Executive Director's Recommendation

Commission Meeting: January 5, 2017

Installation of Ground Mounted Photovoltaic Panels, Sites 1, 4, and 34

Joint Base Anacostia - Bolling
1314 Harwood Street, SE
Washington, DC

2014 vs 2016 Proposed Future Condition (South Capitol Street Bridge)

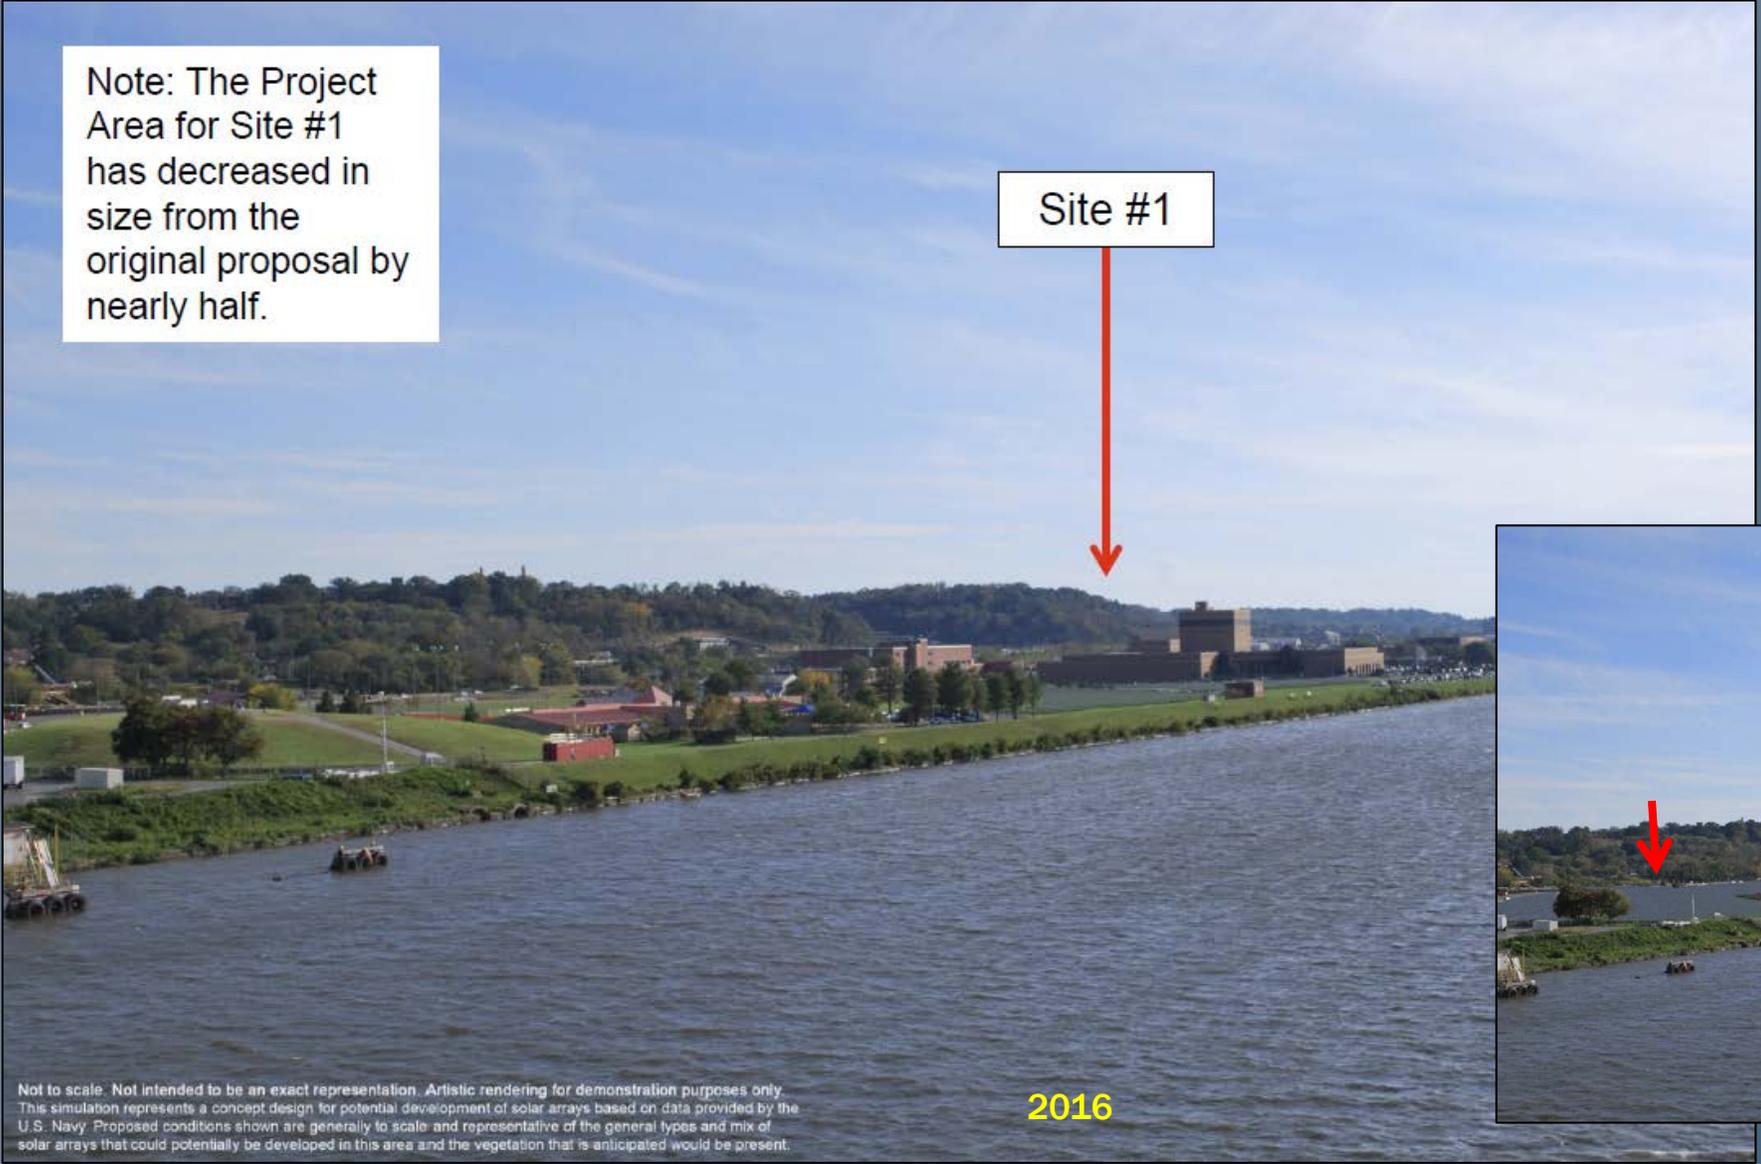
As the northern-most site, closest to the South Capitol Street Bridge, with little existing development, Site 1 has the greatest potential for adverse visual impacts from the west-side of the Anacostia River and from the South Capitol Street Bridge. Initially, when the project was submitted for staff-level review in 2014, the Navy provided photo simulations that show a large expanse of arrays clearly visible from the Bridge and west of the Anacostia River (Buzzard Point). Slides 7 and 11 show the 2014 photo simulations from these vantage points. In response to NCPC staff recommendations, the Navy scaled back the Site 1 array and will require the solar provider

Note: The Project Area for Site #1 has decreased in size from the original proposal by nearly half.

2016 Proposed Future Condition – with and without visual mitigation

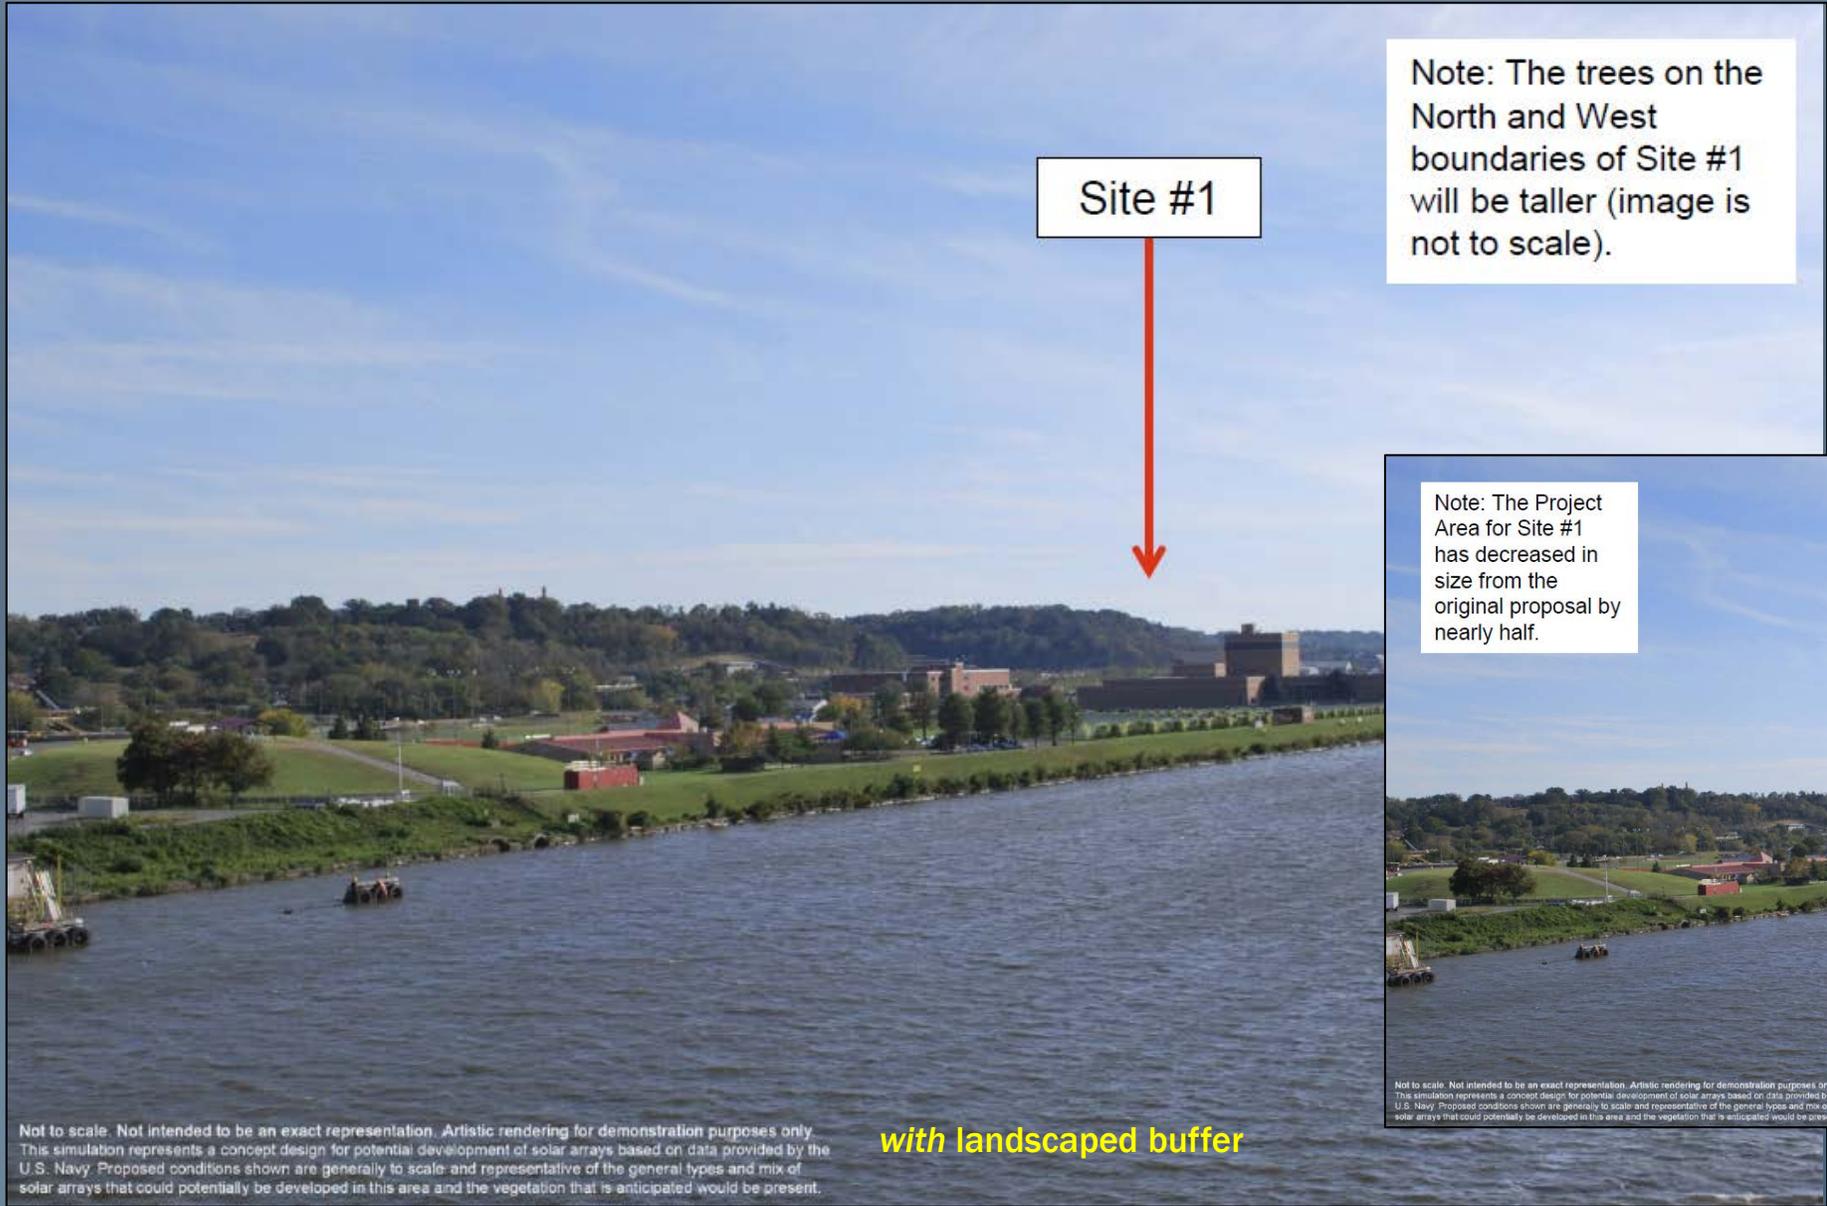
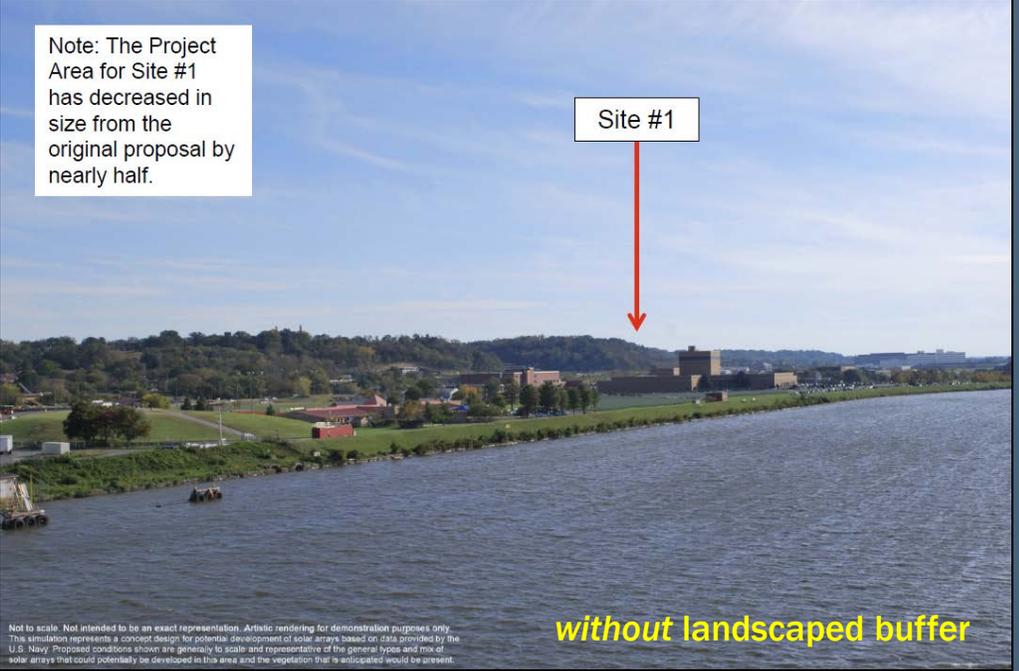
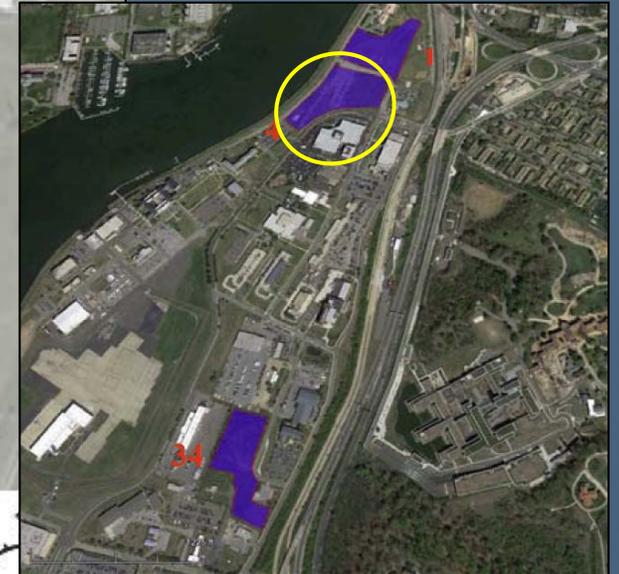
to plant a tree buffer area surrounding the site as shown in the Slide 9 and 13 photo-simulations. Also, the tree buffer along the northern edge of Site 1 will be 15 feet (rather than 12 feet) to provide additional visual protection from nearby off-site locations. Based on the photo simulations, NCPC staff believes that the project will not result in any significant adverse visual impacts to the two visually-sensitive vantage points that were considered as part of the project planning process.

Note: The trees on the North and West boundaries of Site #1 will be taller (image is not to scale).
